APPEAL SUMMARY

Appeal ID: 16163	Project Address: 7152 N Vancouver Ave	
Hearing Date: 11/22/17	Appellant Name: Tom Jaleski	
Case No.: B-014	Appellant Phone: 5034885651	
Appeal Type: Building	Plans Examiner/Inspector: Tara Carlson	
Project Type: residential	Stories: 3 Occupancy: Townhouses Construction Type: VB	
Building/Business Name:	Fire Sprinklers: No	
Appeal Involves: Erection of a new structure	LUR or Permit Application No.: 17-237872-CO	
Plan Submitted Option: pdf [File 1]	Proposed use: Townhouses

Appeal item 1

2014 ORSC R302.2.7

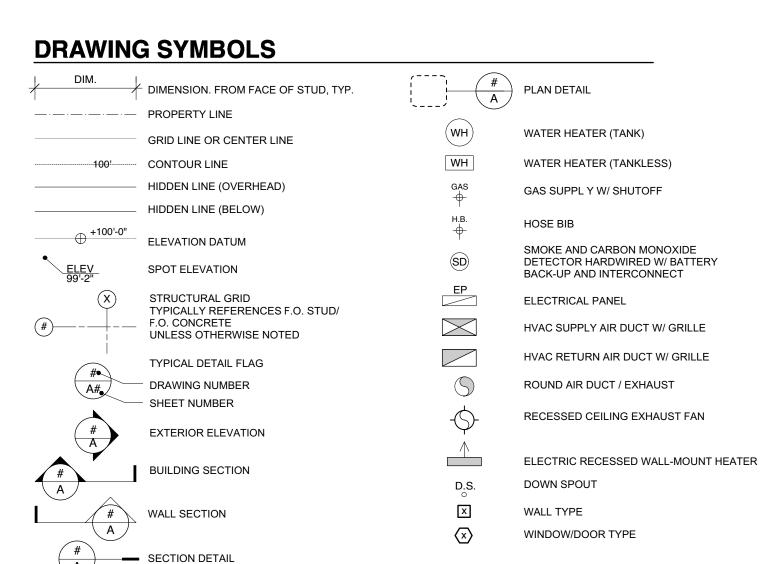
The proposed design for lots 2, 3, 4, 5, 7, 8, 9,10, and 12 of the Origami Townhouses where windows on the exterior walls are less than 3 feet from the common property line and the walls are less than perpendicular to the common property line are as follows:

The fixed windows will have a fire separation distance of at least 10 feet to the common property

line, exceeding the requirement of Table R302.1.

The walls within 3 feet on either side of the common property line will have a 1 hour rated assembly with non-combustible siding.

The proposed design is to provide 1 hour rated walls with non-combustible siding on the exterior walls and have the windows located so that the fire separation distance to the common property line is at least 10 feet. 2014 ORSC Table R302.1 allows unlimited quantity of unprotected windows where the fire separation distance is only 3 feet, much less than our proposed design. The walls where the windows are located have angles less than perpendicular, but greater than 70 degrees, and allows windows near the common property lines to have a fire separation distance of 10 feet to the common property line. The fire separation distance is defined in R202 as the distance from the building face at a right angle, to the closest lot line. The fire separation distance of the windows in the proposed design, as shown on the attached plans, is at least 10 feet from the edge of the window closest to the common property line. The exterior walls are 1 hour rated exterior wall assemblies as required per R302.2.6.1 with the additional protection of non-combustible siding. These assemblies will mitigate the potential for fire and smoke spread between townhouses. ORSC R302.2.6 and R302.2.7 are meant to prevent the spread of fire and smoke between townhouses where the walls are less than 90 degrees to the common property line. These code sections do not address the varying degrees of wall angle to the common property line. The code section is roughly based on testing by NIST in Technical Note 1600, attached, where parallel walls are tested with a fire separation distance of 3 feet. The openings in the test are are directly in line with each other and the test shows that the window in the adjacent unit did not break until the temperature reached 1000 degrees Fahrenheit (560 C). The openings in the proposed design are oriented less than 15 degrees from perpendicular to the common property line and provide additional protection against the migration of fire and smoke between windows by having a fire separation distance of at least 10 feet. Table R302.1 allows unprotected openings with a fire separation distance of more than 3 feet. This is consistent with the NIST test where it showed that windows lined up and 6 feet from each other. The proposed design greatly exceeds the tested conditions in relation to angle between the openings and fire separation distance. The additional protection measure provided of fire separation distances of at least 10 feet, greatly exceeds the requirements of R302.1 and provides equivalent protection for the openings to not be impacted by a fire/smoke event in an adjacent townhouse.

Measurement of fire separation distance where wall openings are not perpendicular to the common property line: Granted as proposed with one hour exterior walls rated for exposure to fire from the inside and non combustible siding.
